NUCLEAR REGULATORY COMMISSION

Title: Advisory Committee on Reactor Safeguards
 UP EPR Subcommittee

Date: Wednesday, November 6, 2013

CHAIRMAN POWERS: The purpose of this meeting is to continue our review of the Safety Evaluation Report with Open Items for the combined license applications submitted by UniStar Energy for the Calvert Cliffs Nuclear Power Plant Unit 3.

Aerial View of CCNPP Unit 3 Site on the Calvert Peninsula

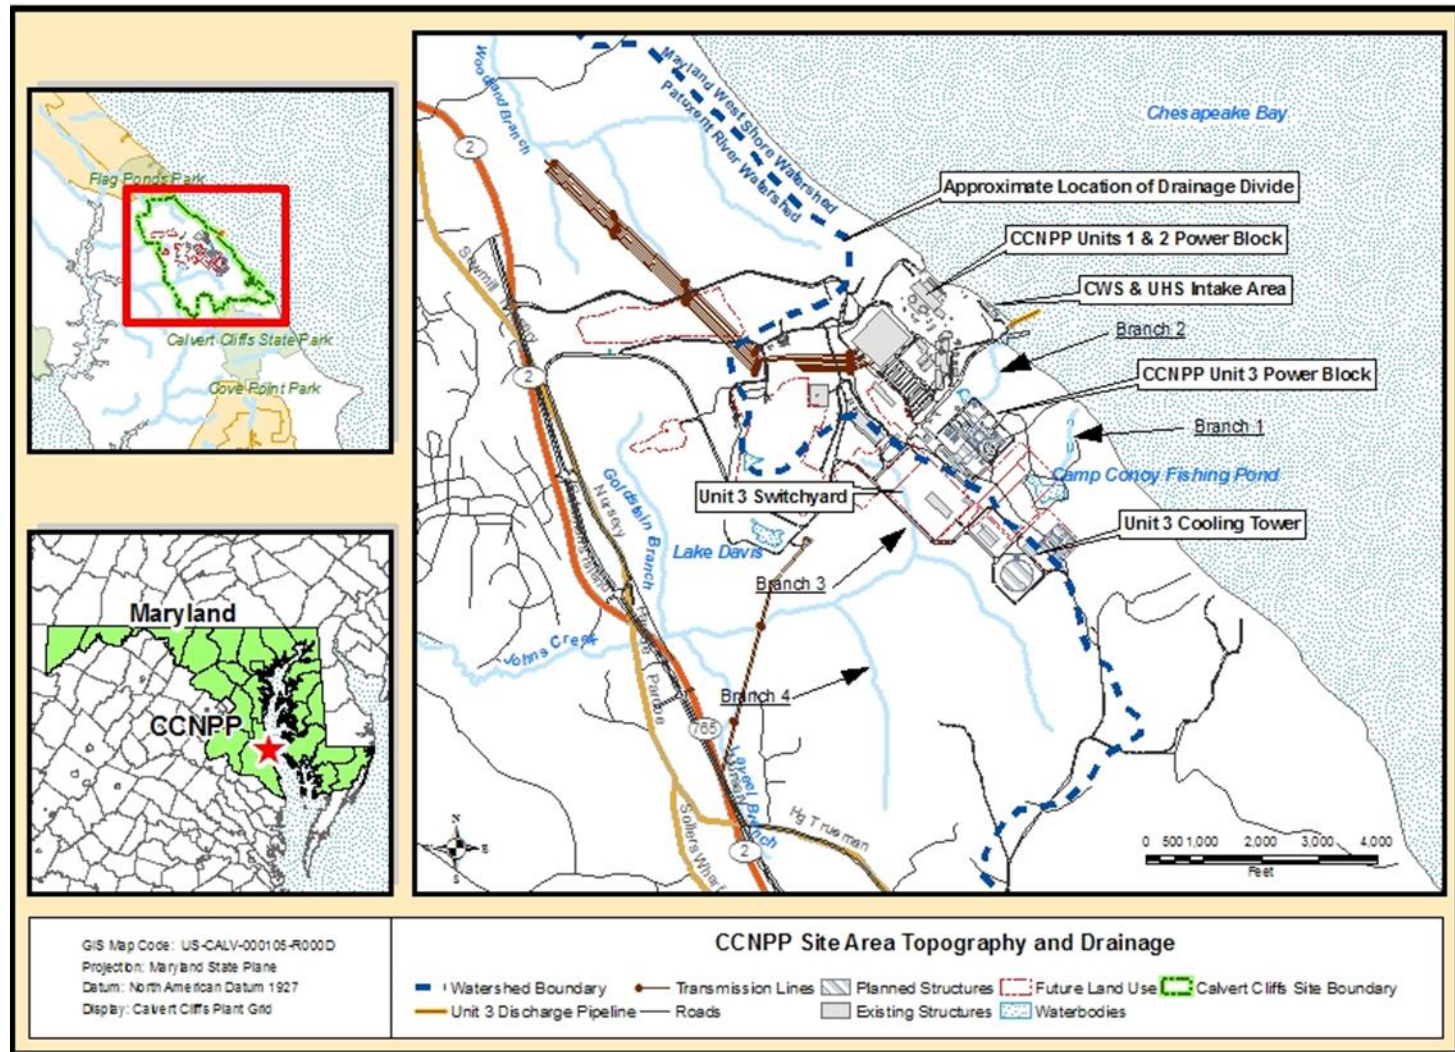
- FSAR Revision 9 Figure 2.4-1 shows the outline of the CCNPP Unit 3 site boundary that appears to be inconsistent with FSAR Figures 2.4-17 and 2.4-25.
- Because the staff uses the CCNPP Unit 3 site boundary in its safety determination related to flooding, it is essential that the staff know which of the applicant's depictions of the site boundary is correct.
- The applicant is requested to provide revised figures in FSAR Section 2.4 that include the site boundary and ensure that the boundary is consistently shown in the figures throughout this section.

Inlet Area Plan View

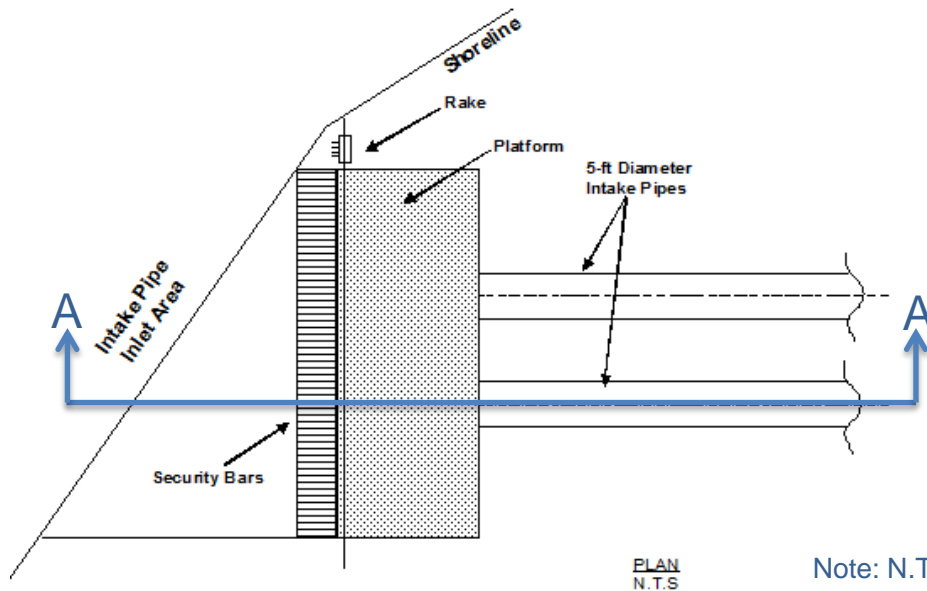
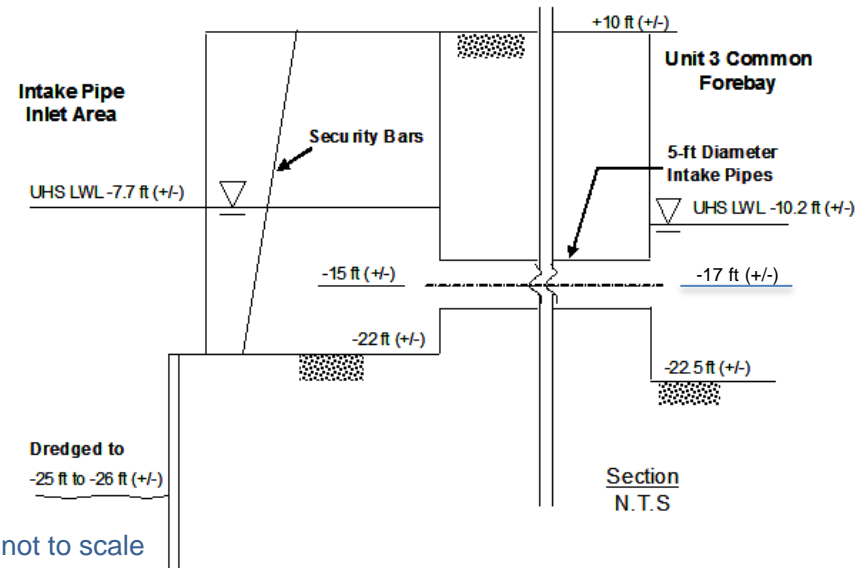
15 But you can see better or another
16 perspective on Slide 36. So this is a blow-up of that
17 intake area where these intake pipes are. On the left
18 slide it's a plan view. So these intake pipes are about
19 five-foot diameter pipes and they're protected with
20 security bars basically, and also that sheet pile wall
21 that we talked about.

22 And the elevation view on the right hand
23 side shows that that particular intake area is dredged
24 to about minus 25 foot just inside the sheet pile wall.
25 And then the pipe elevation itself, centerline, is about
